DEVELOPMENT DETERMINATION PANEL MEETING

WEDNESDAY 7 MAY 2025

ITEM 3.1	MOD2024/0577 - 1 OGILVY ROAD CLONTARF - MODIFICATION OF DEVELOPMENT CONSENT DA2023/0302 GRANTED FOR ALTERATIONS AND ADDITIONS TO A DWELLING HOUSE INCLUDING A SWIMMING POOL
----------	--

APPLICATION FOR MODIFICATION ASSESSMENT REPORT

Image 2 - Proposed modified site plan

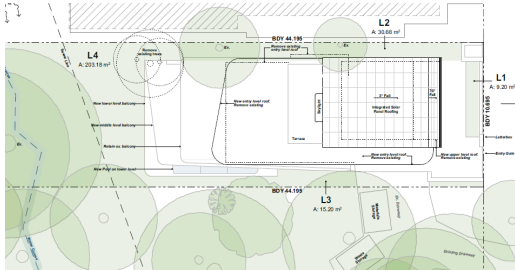
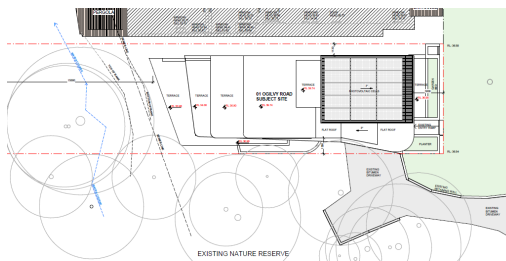
Additionally, **Condition 10. Amendments to the approval plans** is proposed to be deleted. The condition was imposed by the assessing officer and amended by the DDP as part of the assessment of DA2023/0302.

The amended plans reduced the scale of the balcony extensions to the rear of the site.

Proposed level 1

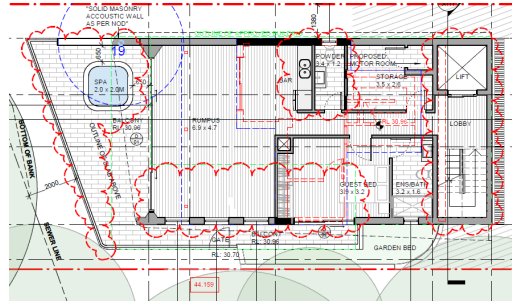
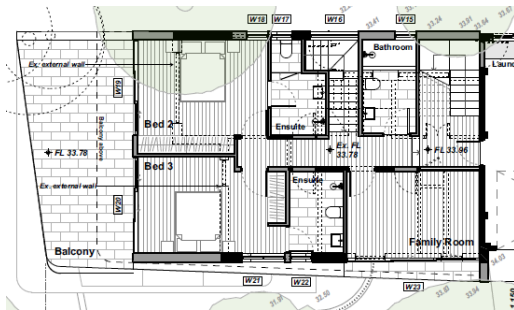
Development standard:	Floor space ratio
Requirement:	0.4:1 (189.04sqm)
Proposed:	Approved 0.58:1 (275.38sqm) Proposed 0.61:1 (289.80sqm)
Percentage variation to requirement:	52.5%

The modification application seeks to extend the rear balconies (Level 1 and 2) of the approved dwelling house.

The amended plans proposed as part of this modification reduce the scale of the balconies and incorporate screening between the subject site and adjoining western property (No. 3 Ogilvy Road).

Comment: Level 02 (formerly labelled as middle level) has incorporated solid screen for the whole extent of the western edge of the balcony. Level 3 and 4 (formerly labelled as upper level and entry level) balconies will not directly overlook the private open space or windows of the adjoining properties to the west. The balconies at both levels (Level 3 RL 36.90) and (Level 4 RL 39.74) would have sightlines over the top of the adjoining western dwelling house and not of windows or balconies.

Image 1: Building height non-compliance shaded in red.

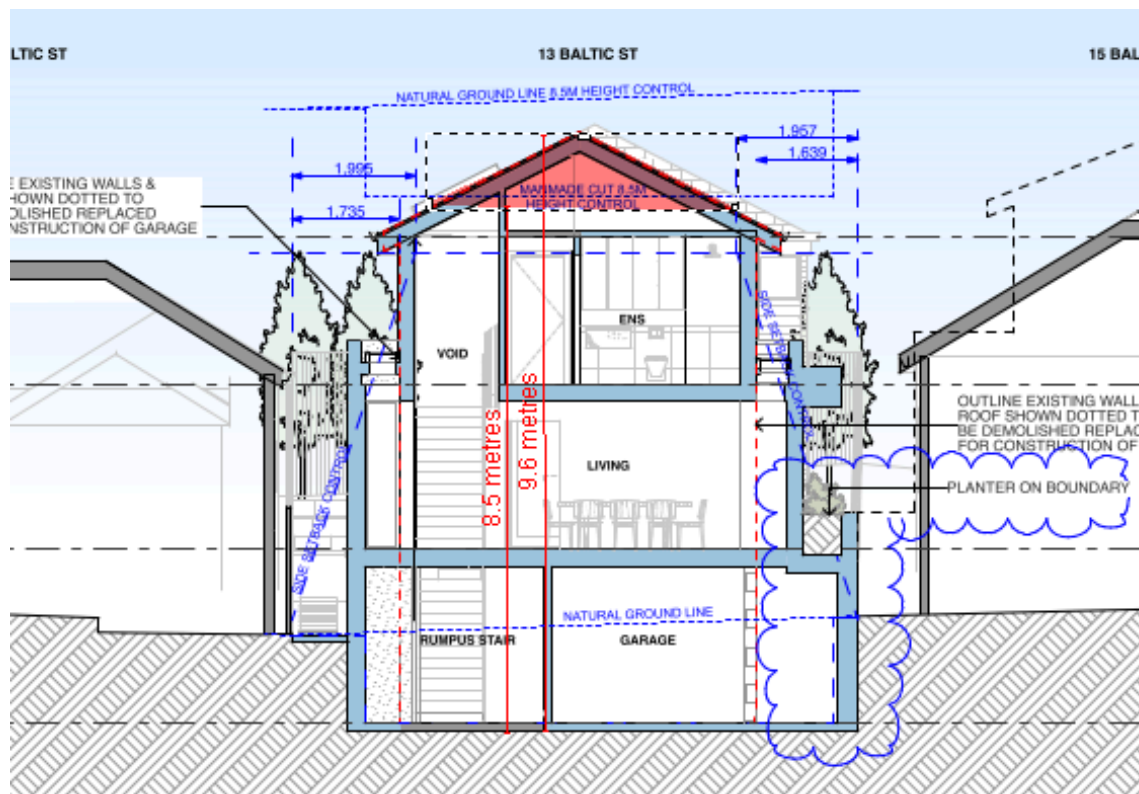
Proposed: 9.6m

Percentage of variation: 12.35%

Image 4: Level 1 - western side boundary setback non-compliance.

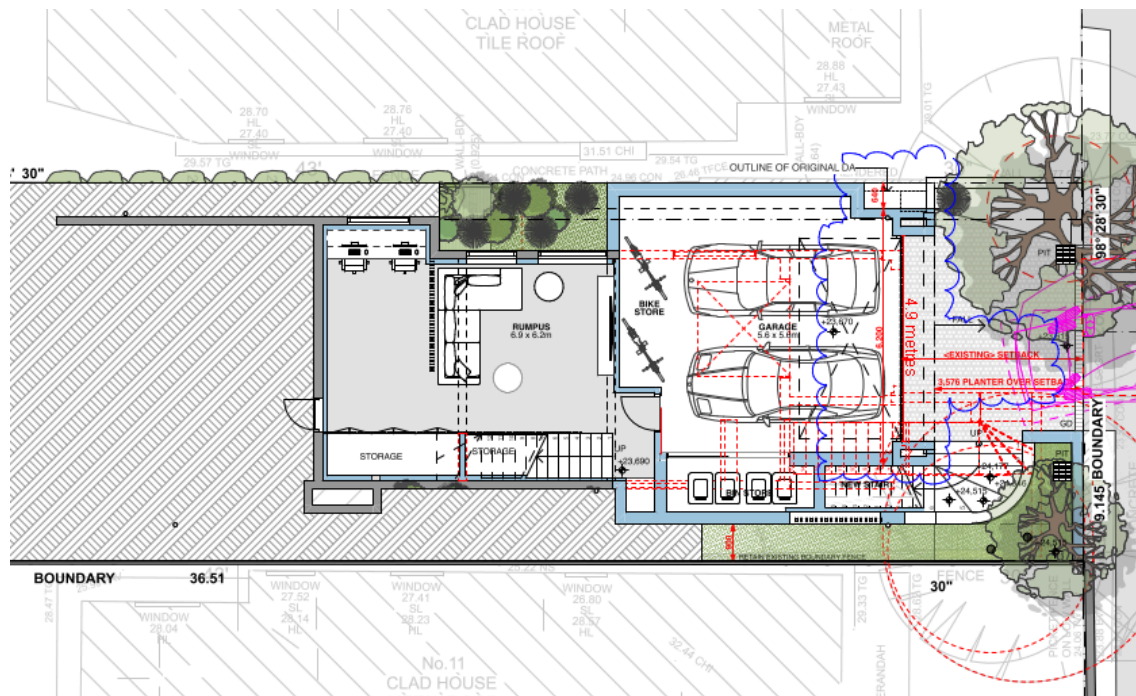
The proposed encroachment on the western elevation meets these requirements and can be considered for a variation.

Image 5: Level 2 - front boundary encroachment highlighted in red.

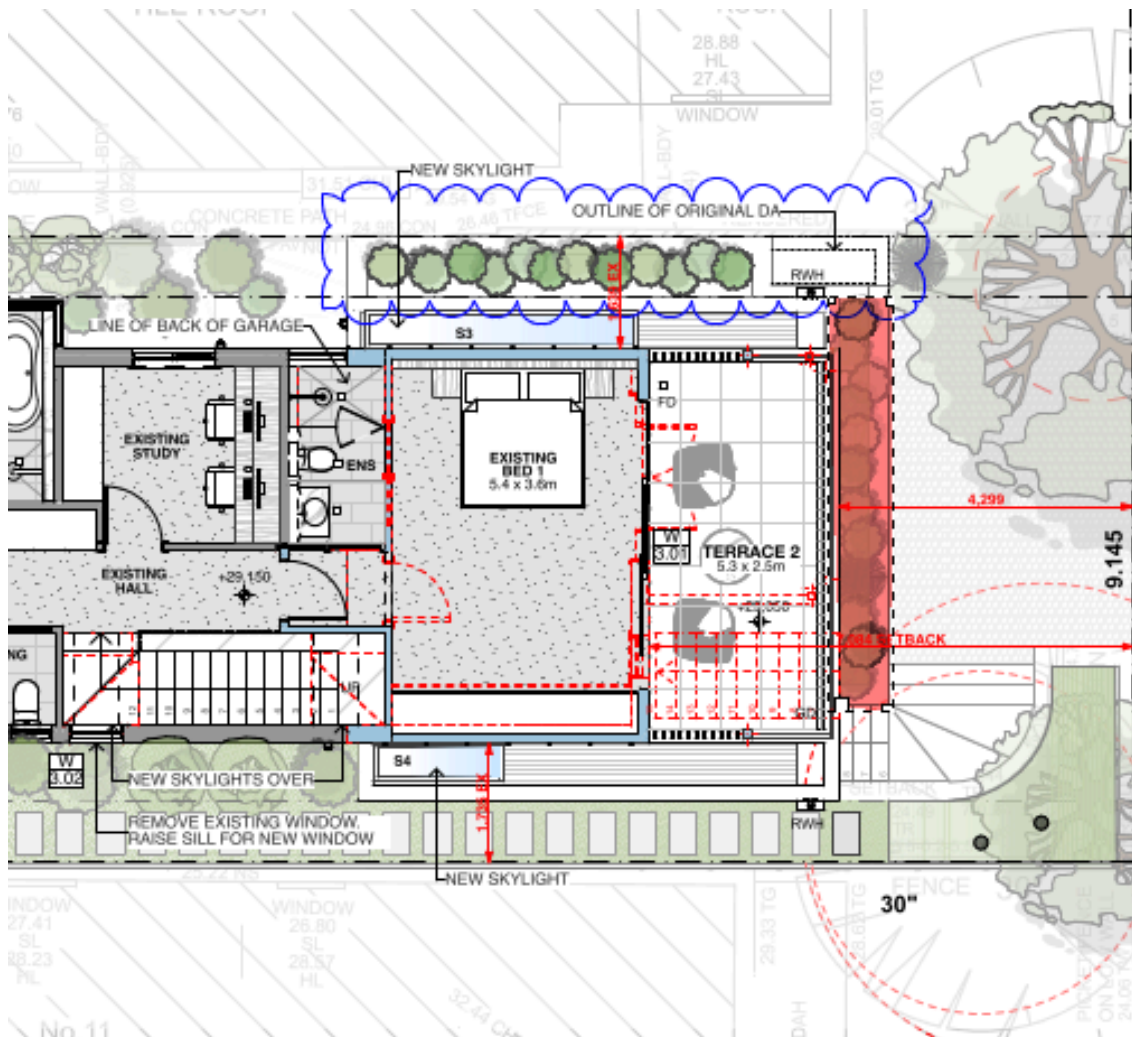
The application, as lodged, was inconsistent with the requirement of the MLEP and MDCP in regards to the setbacks to front and side boundary. The applicant was requested to provide amended plans and information that satisfied Council's concerns.

The applicant submitted amended plans that addressed Council's concerns.

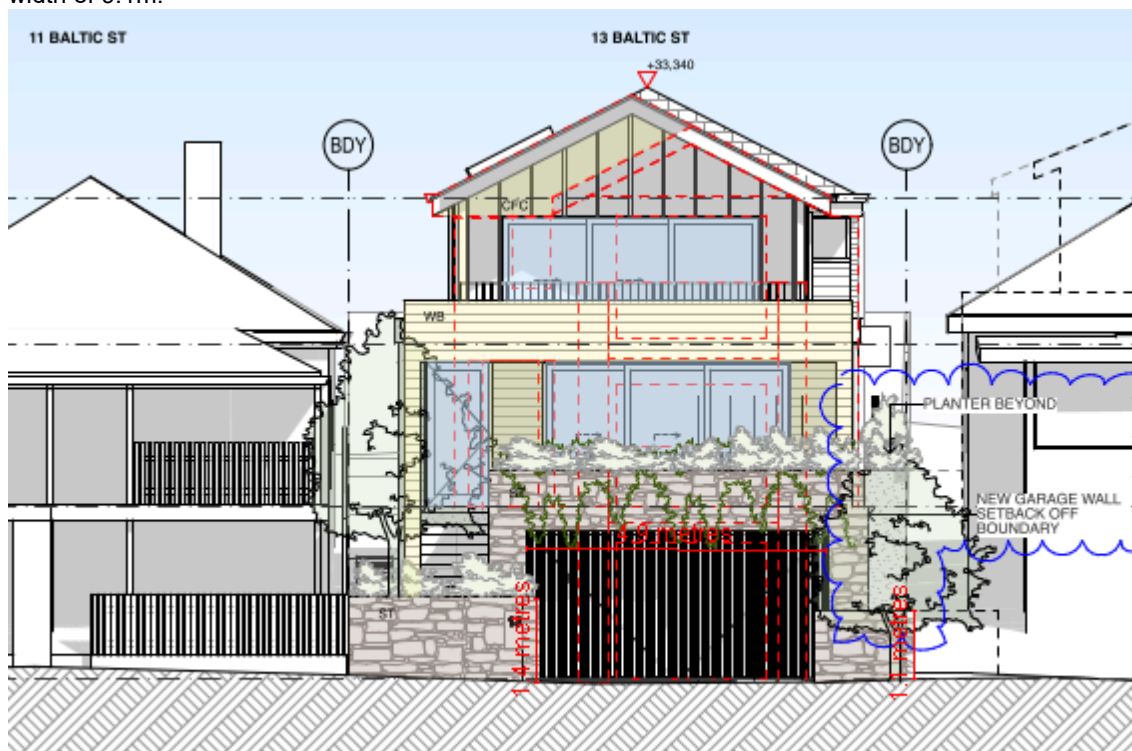
The width of the garage door is 4.9m, which is non-compliant with the width control as the site has width of 9.1m.

Figure 1 - Extract from Section AA (Drawing No. A 303) depicting building height.

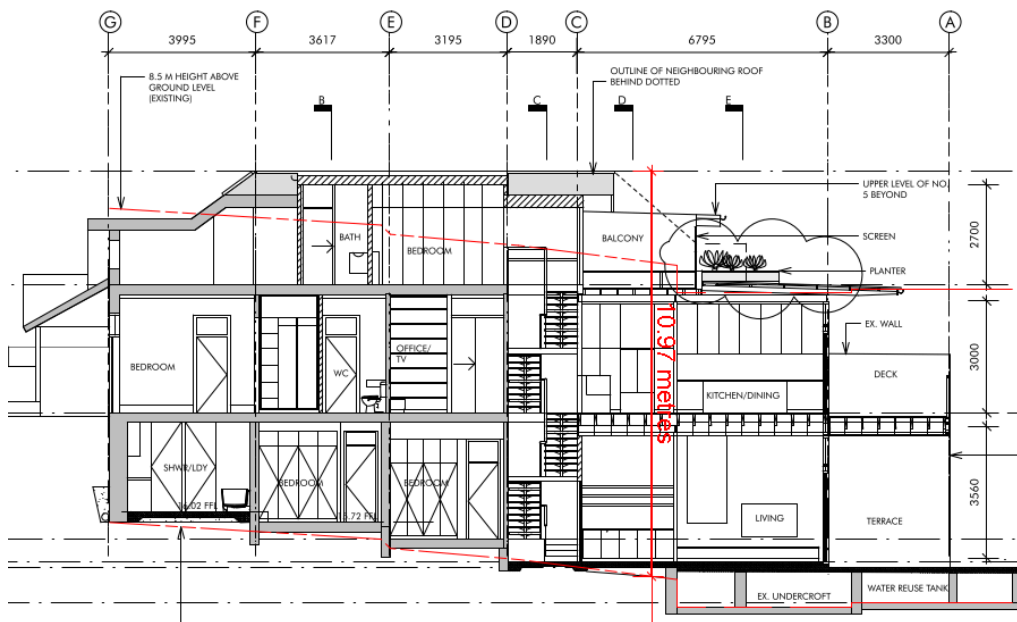
Proposed: 10.97m

Percentage of variation: 29.06%
